**RM2-13**  
**M1305.1**

**Proposed Change as Submitted**

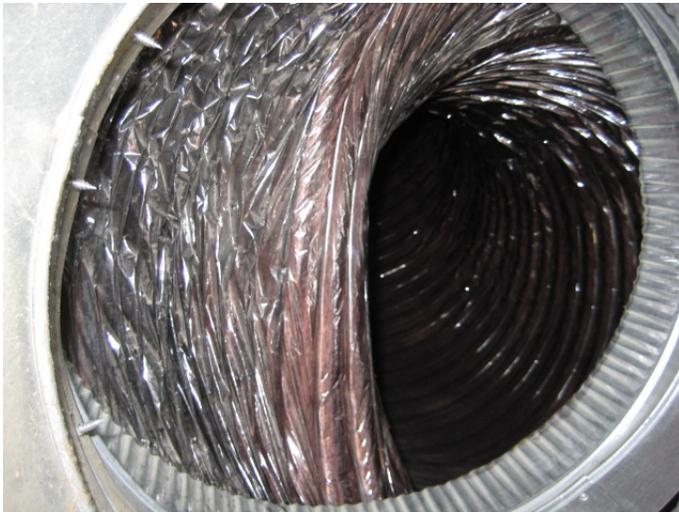
**M1601.4.10 Wall Pass-Through.** The opening in a concrete or masonry foundation wall through which supply and return air ducts from an HVAC unit are intended to pass shall have a width of not less than 42 inches.

**Reason:** National homebuilders are making this opening only 32 inches wide. This is not wide enough for the supply and return air ducts to have a straight run through the wall from the supply and return ports on the HVAC unit.
